## **ADDENDUM #4**

### **Rye City School District**

#### **Osborn Elementary School**

#### **Midland Elementary School**

#### ADDITION FLOOR PLAN

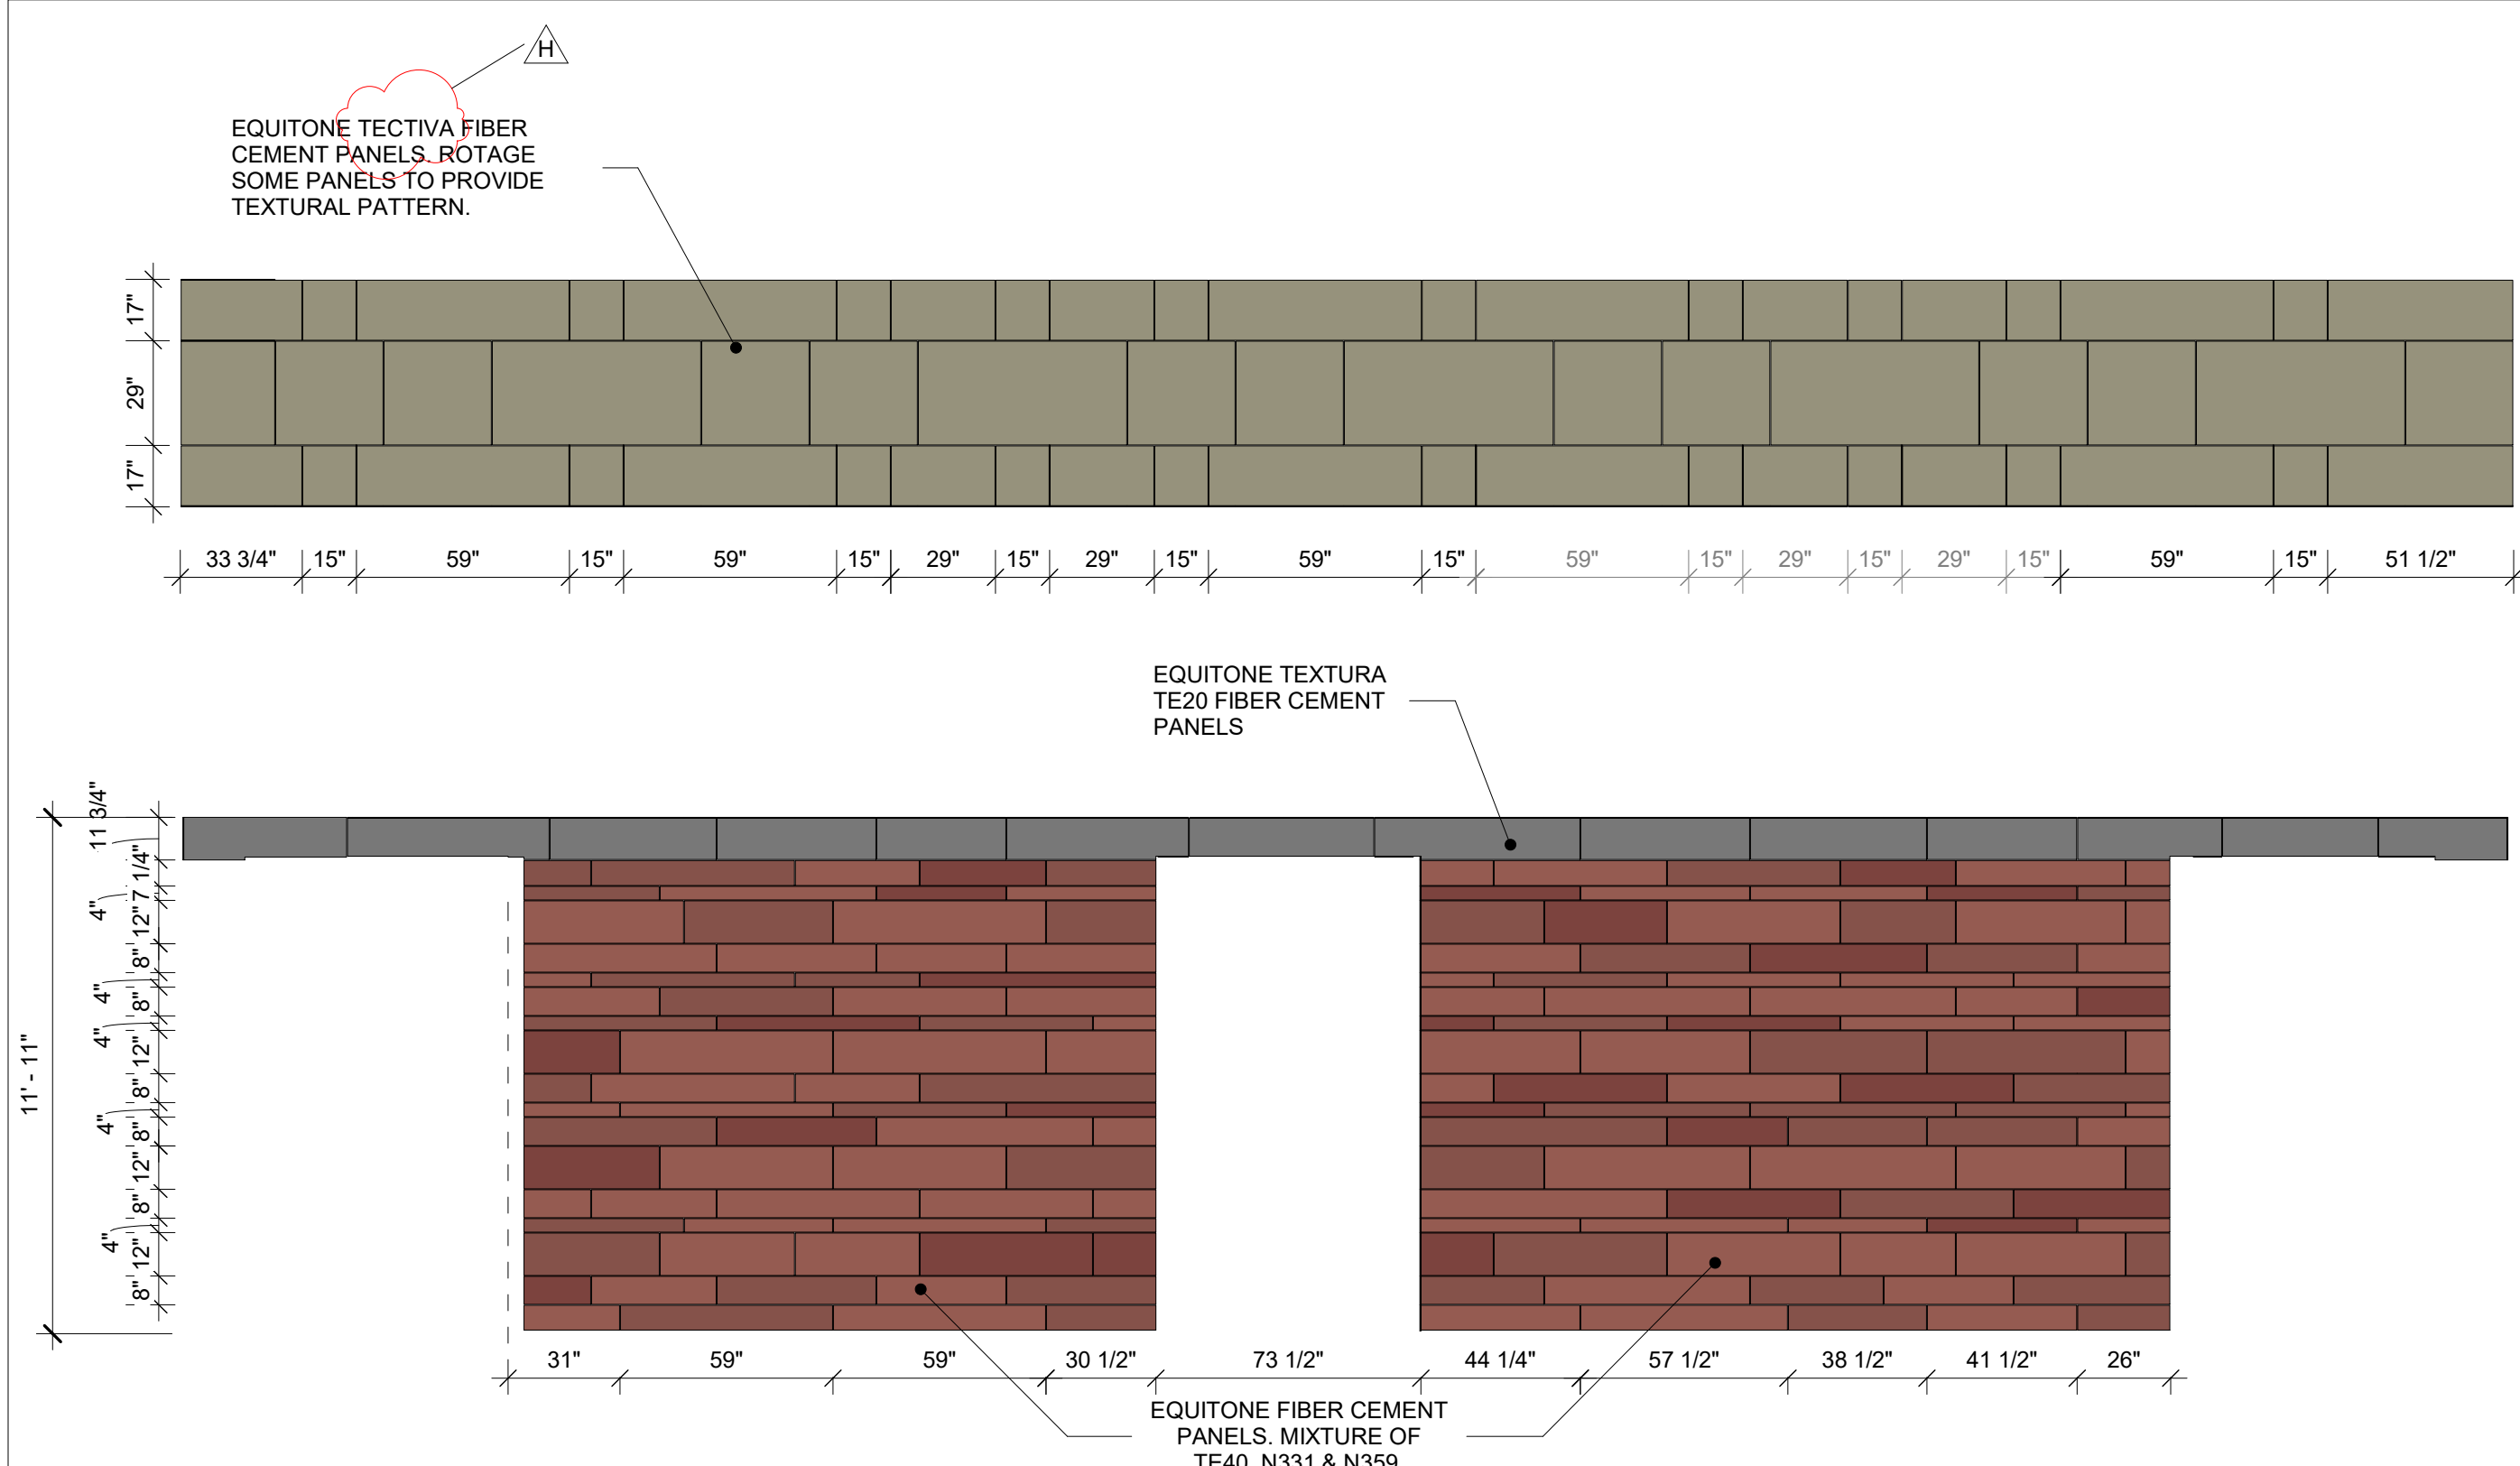
1. A3-120 – ADDITION FLOOR PLAN  
A3-808, A3-807
  - a. Door swing of lockers reversed
2. A3-204 – EXTERIOR CONCRETE PANEL DESIGN – ADDITION  
A3-310, A3-311, A3-312, A3-313, A3-314, A3-320, A3-322, A3-323
